COUNTY OF INYO WATER DEPARTMENT

May 6, 2021

Subject: ICWD concerns regarding well W076 replacement in the Bairs-George wellfield

Figure.1 Bairs Georges monitoring well locations from the preconstruction evaluation. (LADWP 2021).

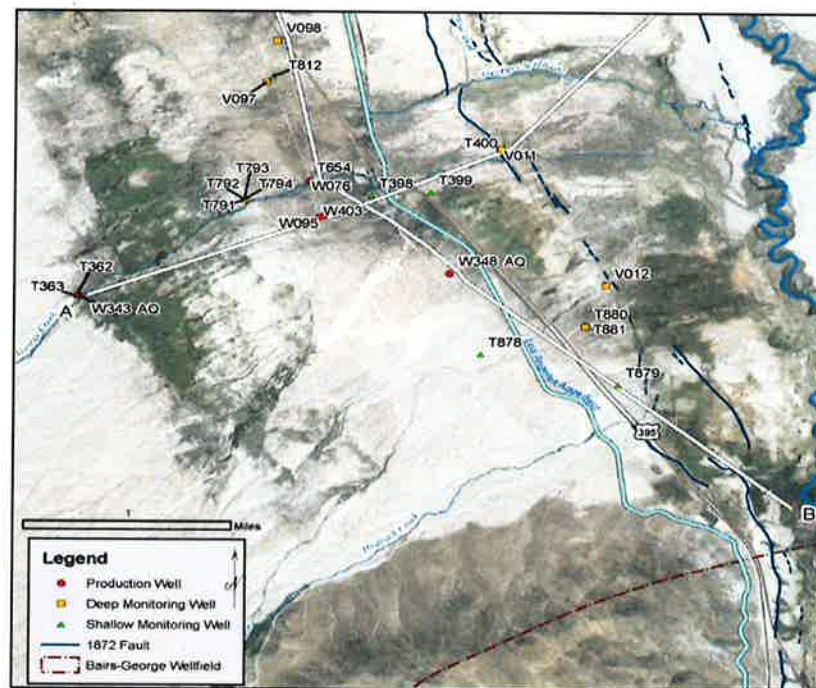
The original W076 was located on the north side of George Creek just west of Highway 395 and the Los Angeles Aqueduct (LAA) (Figure 1). The well was drilled in 1925 to a total depth of 210 feet. The perforated interval was from 10-210 feet below ground surface (bgs). Well W076 had an original instantaneous capacity of approximately 3.8 cubic feet per second (cfs) before 1970, but slowly lost capacity and was approximately 2.6 cfs when described for the 1991 EIR. Notably, W076 was abandoned in the late 1990s after sitting idle since 1990 and was not pumped after implementation of the Water Agreement (LTWA) management procedures.

LADWP plans to drill the W076R replacement well approximately 0.25 miles to the east of the original W076. The well would be located adjacent to the George Creek sand-trap and the LAA. Total depth is planned to be approximately 400 feet with a screen interval from 50 to 400 feet.

Figure 2. Depth to water in shallow BG monitoring wells T596 and T598.

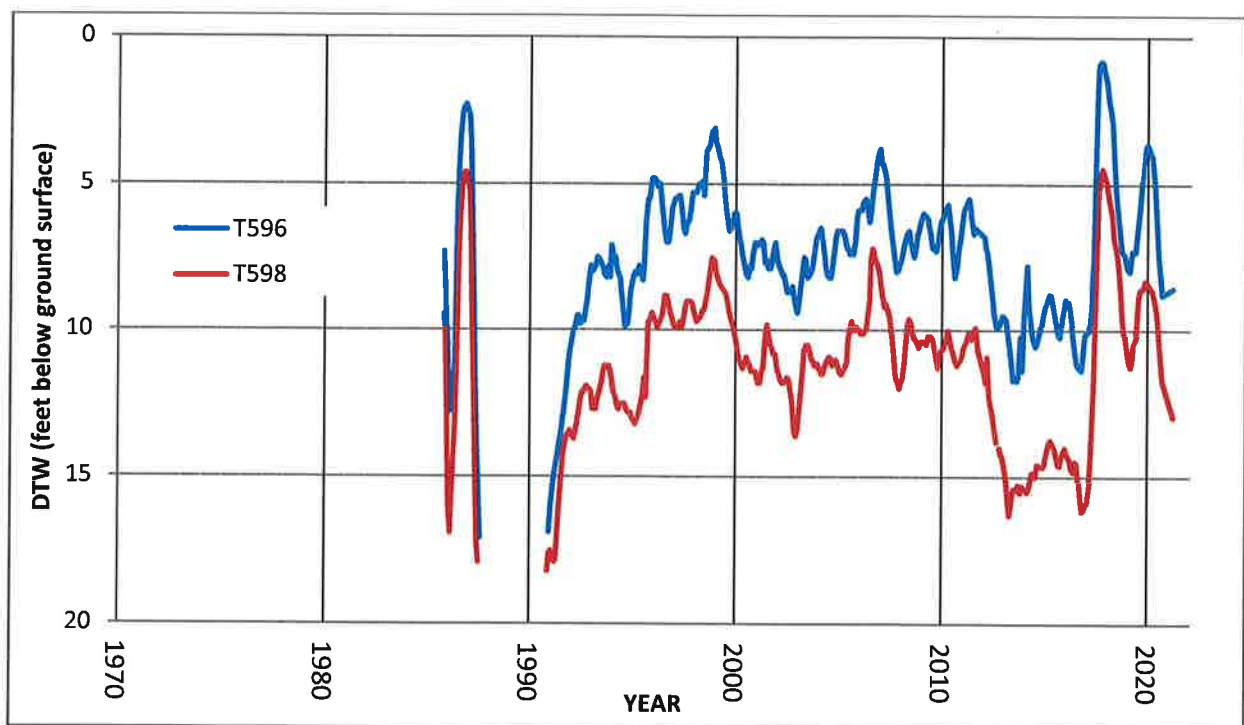
Groundwater levels in both shallow and deep aquifer zones in Bairs-George experienced declines during the 2012-2016 drought. The aquifers recovered in 2017 due to historically high runoff; however, groundwater levels in both aquifer zones have dropped in two of the past three years due to increased BG pumping. Since 2000, the largest groundwater declines occurred in years with greater wellfield pumping (Figures 2, 3, and 4). For example, in 2020-21, LADWP pumped 2,400 ac-ft of groundwater from BG, causing the notable water level declines since April 2020.

LADWP's current instantaneous capacity in the BG wellfield is about 3.9 cfs which equates to 2,800 ac-ft/year of potential pumping. Groundwater declines of about 5 ft occur when pumping is between 2,000-2,500 ac-ft/year as was observed in 2018-19 and 2020-21 (Figure 4 and Table 1). Well W076R would increase the BG wellfield capacity by approximately 1,900 ac-ft/year (total capacity = 4,700 ac-ft/year). The preconstruction report compares current BG pumping capacities to historic pumping practices, noting that the pumping has decreased since implementation of the Water Agreement. However, pumping from 1987-1989, when the average annual amount was about 4,800 ac-ft year, led to water table declines of more than 10 ft. This drawdown caused substantial water table and vegetation declines (Figure 2 and 3 and vegetation changes discussed below).

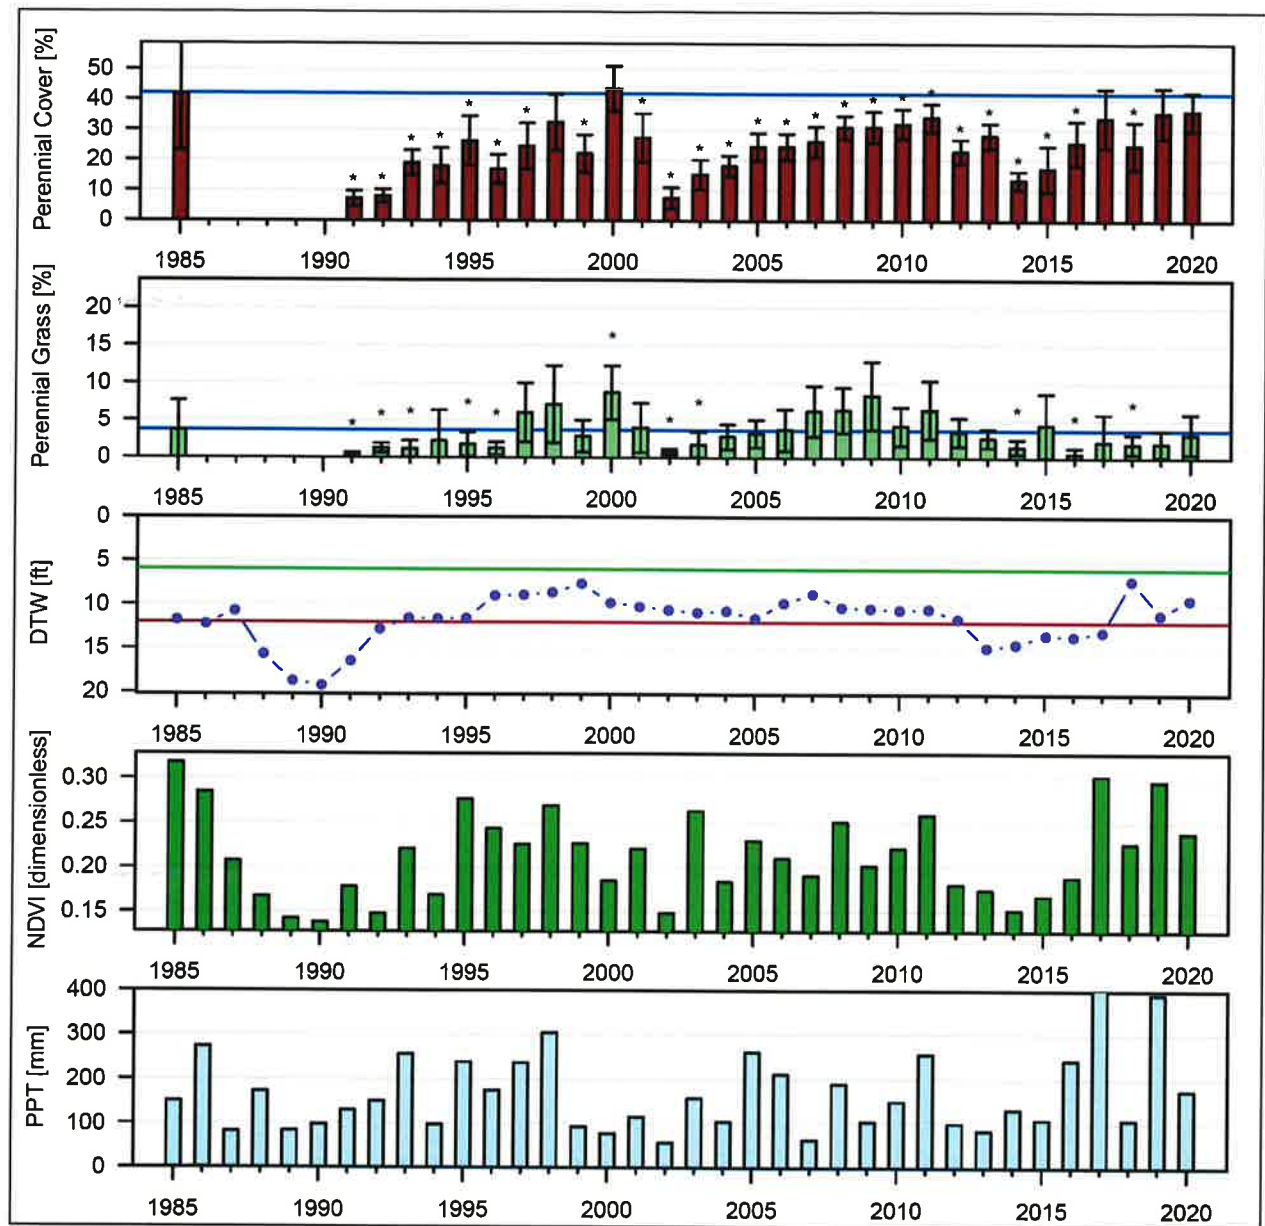
Vegetation parcel MAN037 is a Type-B parcel and the current soil moisture is within the rooting zone for phreatophytic shrubs (13.1 ft). Cover in this parcel increased steadily following a fire in 2002 but declined during the 2012-2016 drought (Figure 6). Cover had been below baseline for more than 25 years but was not significantly below baseline in 2017, 2019, and 2020. MAN038 is a Type-C meadow parcel dominated by shallow-rooted perennial grasses, the cover of which has been significantly below baseline during the last two years (2019, 2020). Much of the southern portions of these two parcels are within a few hundred meters of the proposed well location and consist of high cover meadow or shrub willow/rose vegetation. Example photographs from transects in MAN 037 and 038 are provided at the end of the letter.

Both historic and groundwater model evidence of possible water table declines in the area of this shallow rooted and vulnerable vegetation type supports the concern that W076R would likely cause vegetation cover declines unless pumping is severely restricted to limit water table declines. Before operating the replacement well, the Technical Group should evaluate whether or not the deviation from baseline in MAN038 parcel is attributable to the current groundwater extraction practices from the BG wellfield before considering adding additional pumping stress to the ecosystem. Additional information about vegetation conditions in this wellfield are available in previous ICWD annual reports.

Figure 7. Flow at Reinhackle Springs (blue) and LAA Flow at Alabama Gates, appx 2.5 miles south of Reinhackle Springs.

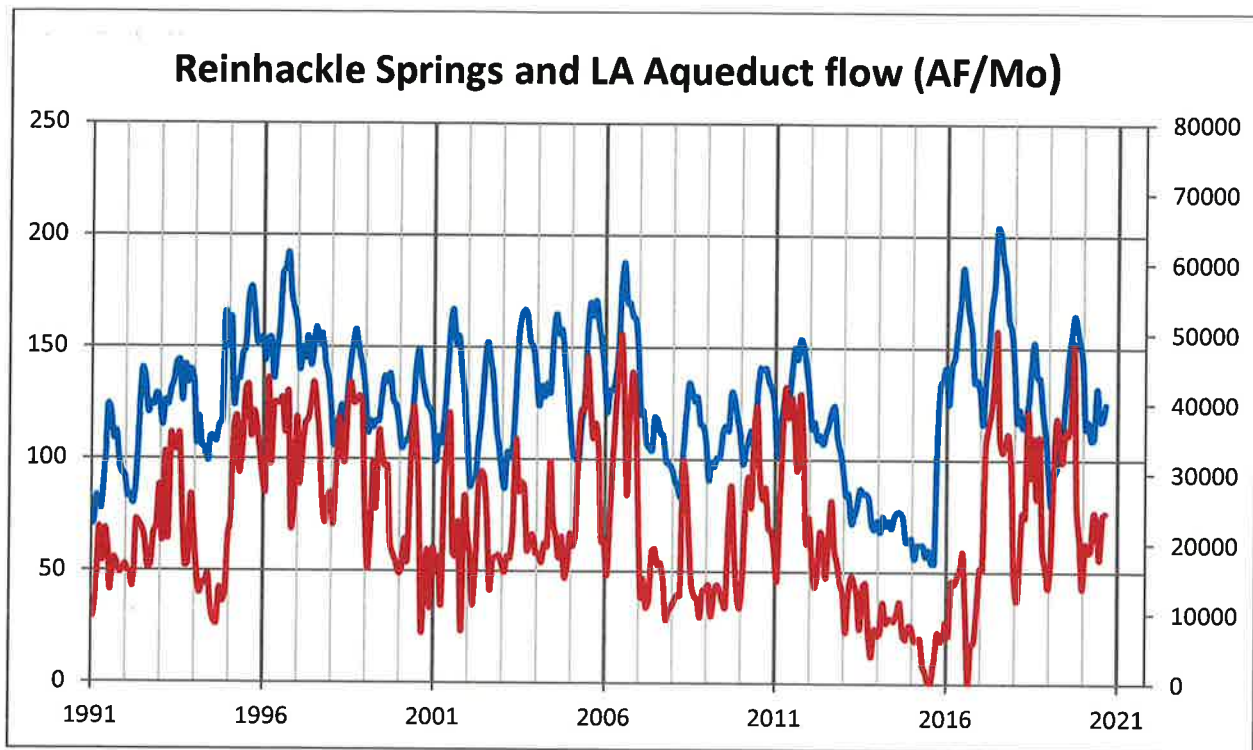
North-south trending faults in Bairs-George create layers of low-conductivity materials which restrict natural groundwater flow paths causing groundwater upwell and discharge along the numerous fault traces including Reinhackle Springs. Both geochemical data from the Inyo/LA Geochemical Cooperative Study in 2004 along with long-term hydrologic data (spring discharge, LAA flows, monitoring well hydrographs) suggest Reinhackle spring/seep discharge is from recent recharge most likely related to shallow west-to-east groundwater flow and LAA seepage being impeded by Owens Valley Fault system. As is seen in Figure 7, increase and decrease in Reinhackle Spring discharge coincides with flow changes in the LAA. Note the persistent large decline during the 2012-2016 drought when flows in the aqueduct were at or near historic lows. In 2016 in Reinhackle flows increased quickly when near normal flow returned to the LAA and, as reported by LADWP staff, that after being dry for part of 2015, the unlined portion of the LAA in Bairs George was leaking at greater rates.

Based on LADWP's proposed construction for W076R with screened intervals in the shallow aquifer and W076R's more proximate location to Reinhackle spring/seep discharge; it is likely that pumping from W076R will either capture some of the aqueduct seepage or reduce the upwelling in shallow aquifer zones upgradient of the spring and, therefore, reduce discharge in the Reinhackle Springs area. The model results may support this hypothesis but were not included in the evaluation. Please provide the modeled spring flow results to the Water Department.
